Service Letter

SL05-454/HMH August 2005

Tool for Lifting of Main Bearing Cap Engine types: 60-98MC/MC-C/ME/ME-C

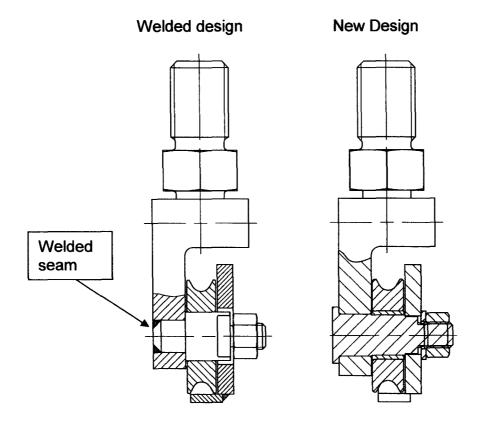
MAN B&W Diesel A/S Denmark Reg. No.: 39 66 13 14 Please note that it is only necessary to make the modification if you have the "welded" version of the tool (se sketch below). If you have the new design with sleeve, further modification is not necessary.

The test result shows that the tool can be used on the 60 and 70-bore engines without any modification. However, to avoid any risk on the 80-bore engines, we recommend this tool to be modified as well (see encl. B of the enclosed SL). Therefore, please fill out and return the check-table and we will send you the instruction and spare parts to modify the tool.

All	60-bore	Update not required
	70-bore	Update not required
	80-bore	Update required
	90-bore	Update required
	98-bore	Update required
